## Residences at Forest Glen, Sketch Plan No. 320200030

Completed: 3/30/2020

Review Basis: Chapter 59, Sketch Plan.

**Figure 13 Site Circulation**

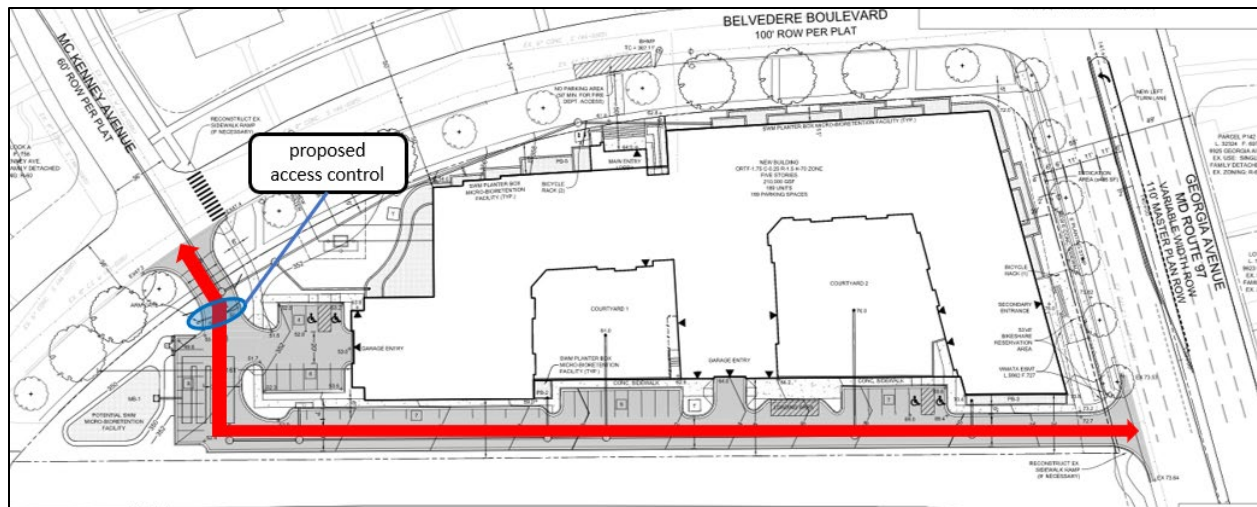
Access is proposed via a private drive aisle that extends from the existing curb cut on Georgia Avenue through the Property to terminate opposite McKenney Avenue, as shown in Figure 13 below. The Applicant proposes two (2) garage-entry points along the drive aisle, which includes surface parking through the aisle. Staff will continue to work with the Applicant on the proposed design of the aisle and its associated parking during review of the Preliminary Plan.

The Applicant is proposing an access control arm at the McKenney Avenue entrance. Staff notes that the Applicant's proposal to provide a continuation of McKenney Avenue through the Property to Georgia Avenue was a response to Staff's request to provide connectivity and accessibility for all travel modes. During the Applicant's LMA review (H-129), Staff indicated that it would request Arthur Avenue to extend through the Property and the LMA review staff report also recommends public access for all modes. Staff will continue to work with the Applicant on accessibility through the Property and may require a public access easement through the Property. If deemed truly necessary at subsequent plan approvals, at a minimum, the proposed access control arm would need to be relocated deeper into the Property to ensure access for vehicles.

Figure 14 Georgia Avenue Section in 2020 Forest Glen/Montgomery Hills Sector Plan

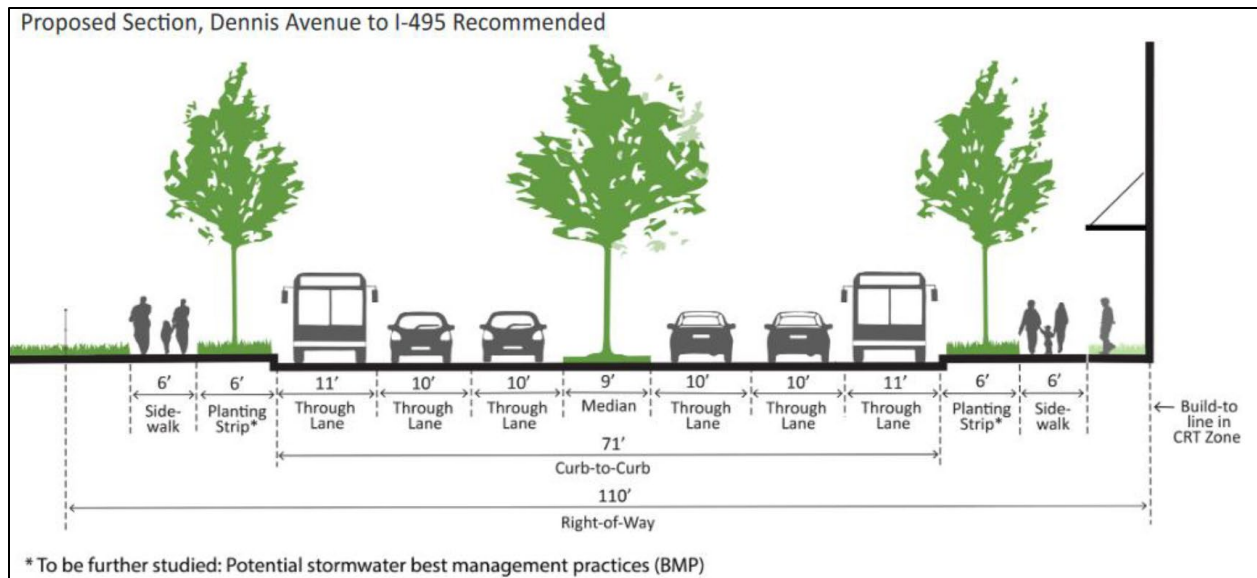
The 2020 *Forest Glen/Montgomery Hills Sector Plan* shows an ultimate 110-foot right-of-way cross section that includes a 9-foot wide median and more narrow travel lanes (Figure 14). As discussed under the "Local Area Transportation Review" header below, the State Highway Administration (SHA) is requesting a northbound left-turn lane to provide queue storage for vehicles waiting to turn left. In order to accommodate this, the nine (9) foot wide median could not be implemented alongside the Property. Staff will continue to coordinate with the State Highway Administration regarding whether the storage lane is necessary as well as discuss the safety benefits of the nine-foot-wide median as shown in the 2020 *Forest Glen/Montgomery Hills Sector Plan*.
